DEPARTMENT OF DEVELOPMENT SERVICES – PLANNING DIVISION
REPORT: Forster Park Renovation Site Plan
for consideration January 25, 2022

STAFF REPORT

PROJECT: Forster Heights Park Renovation
219 Harvard Street
PARCEL ID: 167-714-107
P&Z-COMM-2022-0554

TYPE: Site Plan for the Forster Park renovation per section 3.3.3.D.(2).

Figure 2. Proposed Layout – TO Design 2022

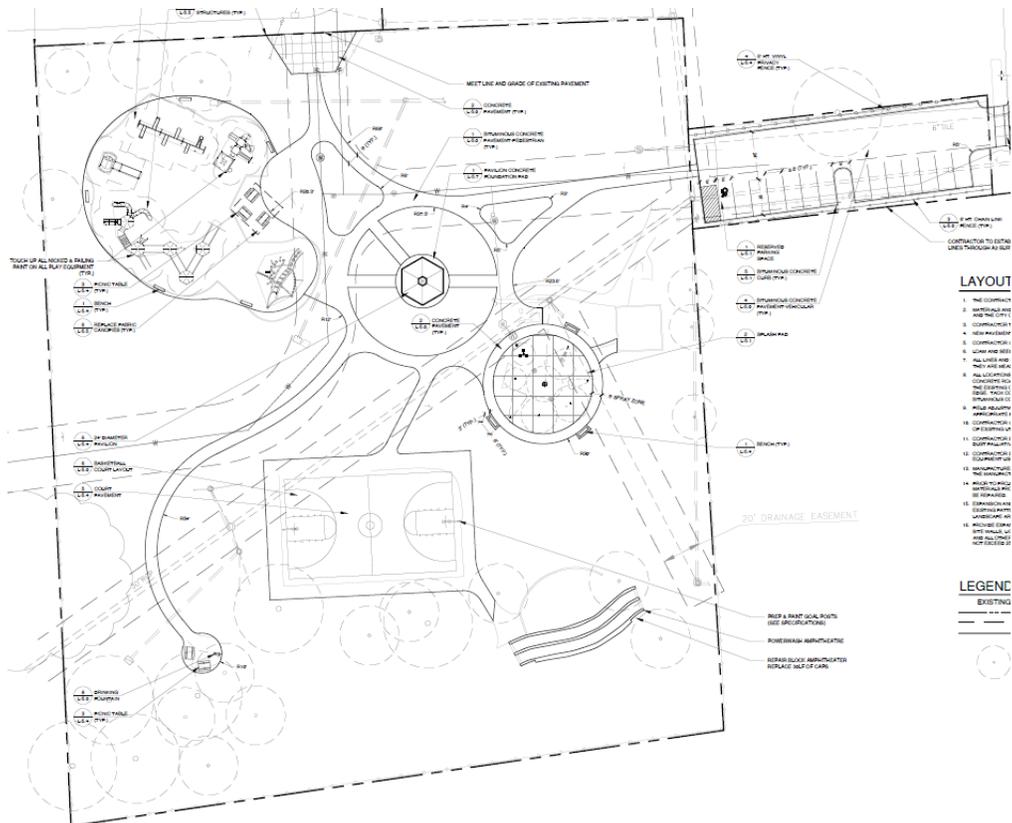
- Investigation of the cause of the soggy ground in the northwest corner of the park has been coordinated with the MDC and the applicant has proposed exploration of some water infrastructure in that sector via remote camera to look for leaks.
- The gap in the fence along Amhurst will be closed with the new fencing.

- The new striping plan appears to increase parking capacity without expanding the parking footprint by increasing efficiency.

All proposed fencing appears to be 6' in height throughout the park including adjacent to roadways and in the front yard. The zoning regulations do not make specific allocations for fences in the OS, Open Space district. However, Section 6.13.2 "Other Districts" provides for the ability of residential uses in certain districts to construct 6' fences in the corner side yard. The nature of the subject park use located within a residential area, combined with the NRZ's concern for security at night gives ample basis for allowing the proposed fence design. Further, the fencing proposed is replacing or repairing existing fencing. The Commission's approval of this site plan would allow the existing conditions to continue.

The current tree planting plan does not appear to meet the requirements for parking lots. The new plan for the lot used for parking for Forster Heights Park includes the installation of a new landscape island. The addition of the landscape island is a needed improvement to provide shade on the parking area and reduce the urban heat island effect, however the tree requirements must be met. The applicant has confirmed they will review the tree plan prior to the Commission meeting for this item.

1. The tree planting plan be revised to meet the requirements for parking lots and a net increase in total tree canopy.
